Response to Further Issues – 9 Burdett Street, Albion

We refer to the above mentioned Minor Change application and the further issues matters previously raised by Brisbane City Council. Please find attached the applicant's comments on the further issues.

Communal Open Space Landscaping

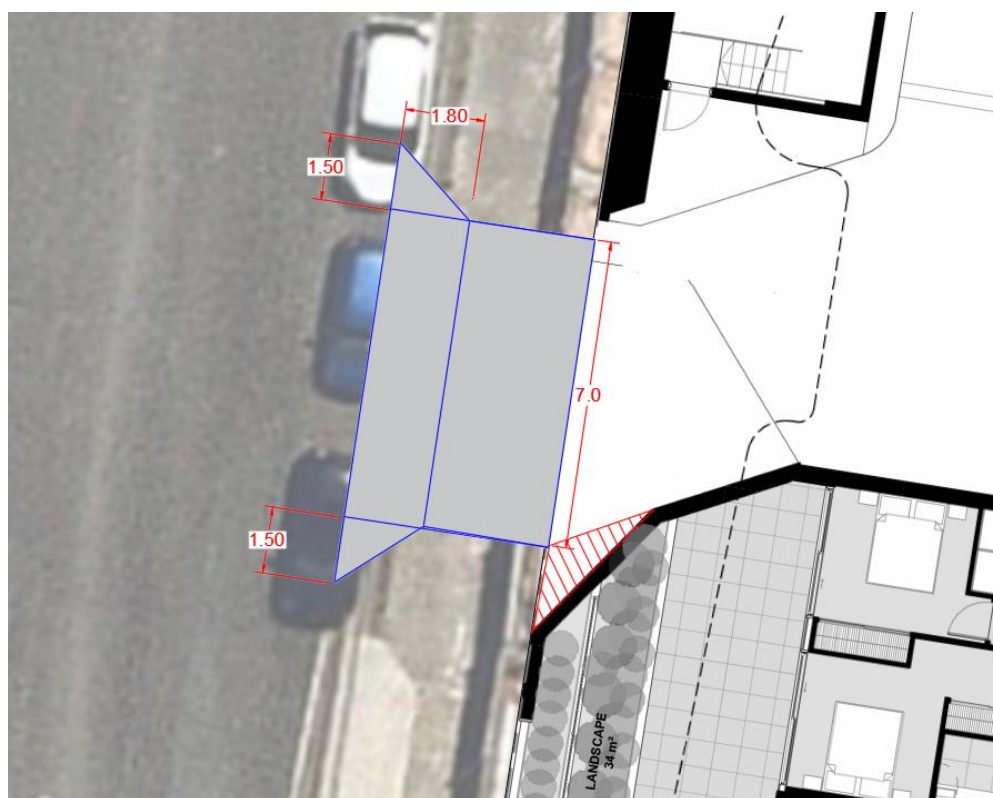
6) It is acknowledged that a Landscape Concept Plan was submitted as part of this s81 Minor Change and that containerised planting areas are proposed above ground level and within the rooftop communal open space. The Landscape Concept Plan did not include details of the proposed containerised planter soil volumes and depths to ensure their long-term success and viability of planting and illustrate how these planters are to be safely and effectively maintained. It is noted that the rooftop communal open space has increased the total area proposed for landscaping but has significantly reduced the number of shade trees to provided to create natural shade and amenity within this space.

Particularly as in-ground deep planting is proposed to be reduced, additional containerised planting should be provided across the site. Revisions are required to the proposed rooftop communal open space to ensure a minimum of 25% of the open to sky space is shaded by trees within 5 years in response to AO30.1/PO31 of the Multiple dwelling code and PO16.2/PO16 of the Landscape work code.

- i) Amend the rooftop communal open space landscape design to include the provision of shade trees to ensure a minimum of 25% of the open to sky space is shaded by trees within 5 years
- ii) Illustrate the containerised planter soil volumes and depths at and above ground level to reflect the minimum requirements of the Landscape design planning scheme policy; and,
- iii) Demonstrate how safe access is to be gained to all containerised planters within the development to allow efficient and effective maintenance to be undertaken.

The communal open space area must incorporate tree planting and landscaping designed to provide shade, visual amenity and a high-quality communal recreation environment.

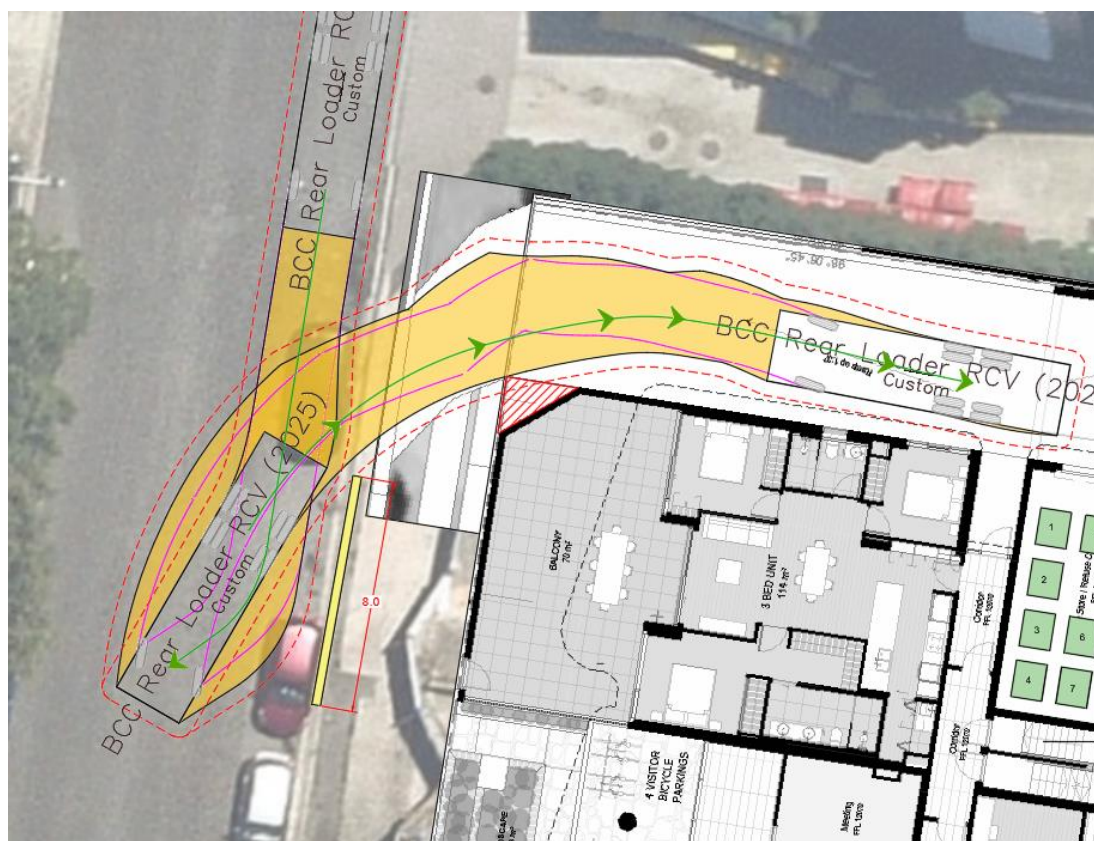
2. Provide amended swept path analysis endorsed by an RPEQ which demonstrates the RCV manoeuvring is functional whether on street parking on Burdett Street is occupied or not, specifically demonstrate the manoeuvre is functional with vehicles parked directly adjoining the southern kerb tapers of the proposed crossover.

Response: To accommodate the current crossover design, the RCV movements will need yellow 'no stopping' line marking for about 8.0m south of the flares. 3 x on-street car parks are required to be removed to accommodate the manoeuvring of the RCV into the service area. Despite this outcome, the reduced driveway crossover does result in minimising the impact of the crossover on pedestrian movement, which is important considering the additional impact on pedestrian movement which results from the addition of the second driveway crossover further south on Burdett Street. Therefore Council's support for the removal of these 3 x spaces is required.
